Access Compliance Report Public Rights-of-Way (Pedestrian Signals)

Main Street: HAZARD_AVE Cross Street: NEWLAND_ST Location: SE

ADA ID: SGRK210929114805 Signal Type: One Push Button-Non APS Overall Compliance: No Severity Scores: BTN 1: 35 BTN 2: N/A No BTN: N/A

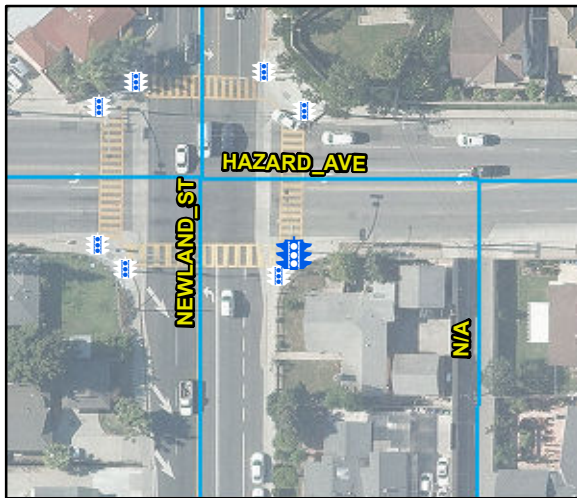
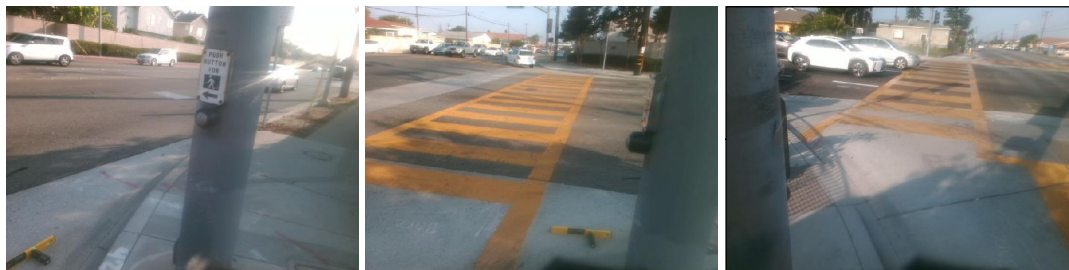
OC Std/PROW: R404.2, MUTCD 4e.08

Possible Solutions: Replace Signal Push Button With APS Button. Remove and Replace Clear Space.
